SOILS EVALUATION

Record Number: EHU-07-25-0680

This soils evaluation is intended for Large Lot subdivision China Garden View Estates.
The proposed lot number is 20 of 45.

Site Evaluation & Soil Report for Lot 20 @ Parcel Number: 411840113

Design: 25-151.20	Date: 7/9/2025
Drawing: 1	Scale: 1" = 50'

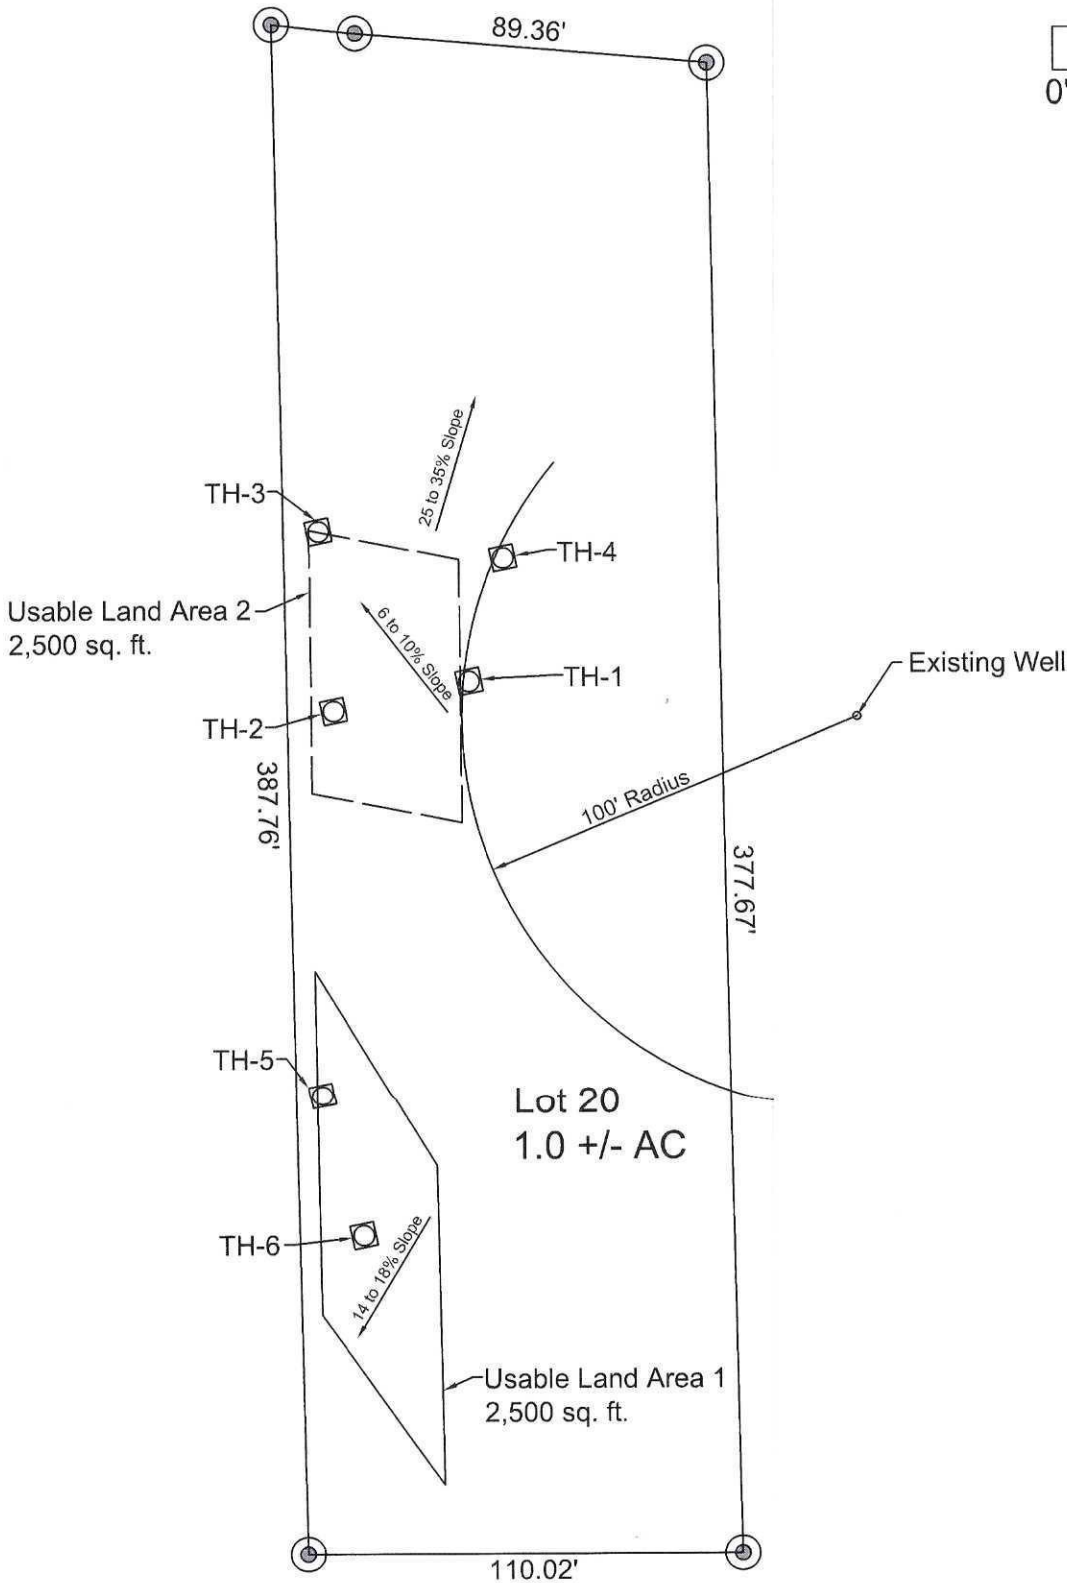
This site appears to be able to, at this time, support an OSS as proposed.

Approved Soil and Site evaluations are valid for five (5) years from the approval date. The proposed septic primary and reserve area(s) set-aside for future septic use must be protected from grading, fill, compaction, or any other alteration that may change soil characteristics. Soil and Site evaluations may be invalidated if the proposed septic area(s) are not protected.

For future well construction: When drilled, the well must maintain a 100' setback from the approved, proposed primary and reserve septic areas or new test holes will need to be opened and evaluated.
